PEDESTRIAN MASTER PLAN

WORK SESSION #3

May 4, 2023

Rock Spring Sector Plan Zoning Map

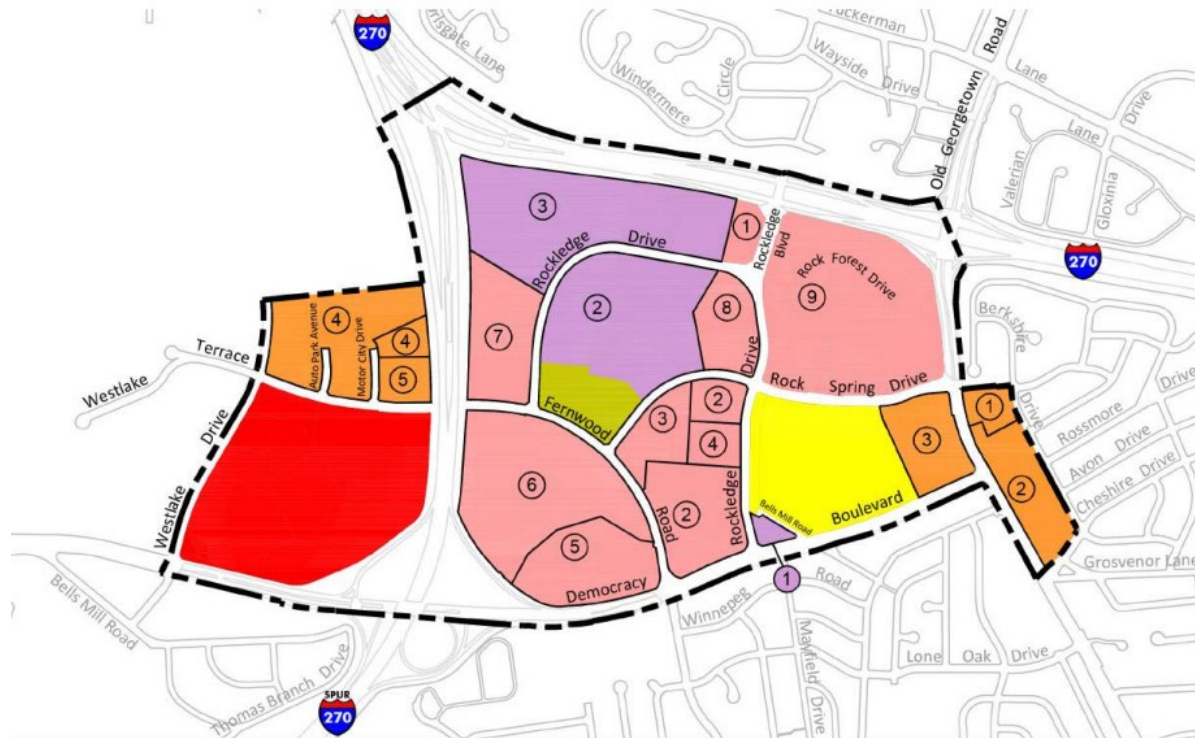
FARs here are mostly between 0.75 to 1.5; far from the 3.0 to 5.0 in more clearly Downtown areas but very in-line with densities in other Town Centers.

Planning Staff Response: Disagree. The Council designated the Rock Spring area as a Downtown in 2022 as part of Bill 24-22 as the request of the Planning Board and Planning staff sees no reason to reconsider this decision. This area a major employment center with consolidated area of commercial-residential and employment zoning designations, high levels of anticipated pedestrian and bicyclist activity and Non-Auto Driver Mode Share (NADMS) goals, as well as planned transit service. The plan envisions a potential of 10 million square feet of commercial development, as well as 4,600 dwelling units, with building heights up to 275 feet.

[Key Action P-4c \(page 104\)](#)

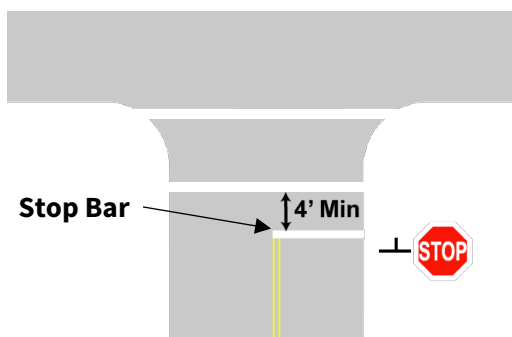
Planning Board Direction in Work Session #2: Update the graphic in Key Action P-7b to identify the stop bar:

Requested Change: Planning staff has made the requested change to the graphic:
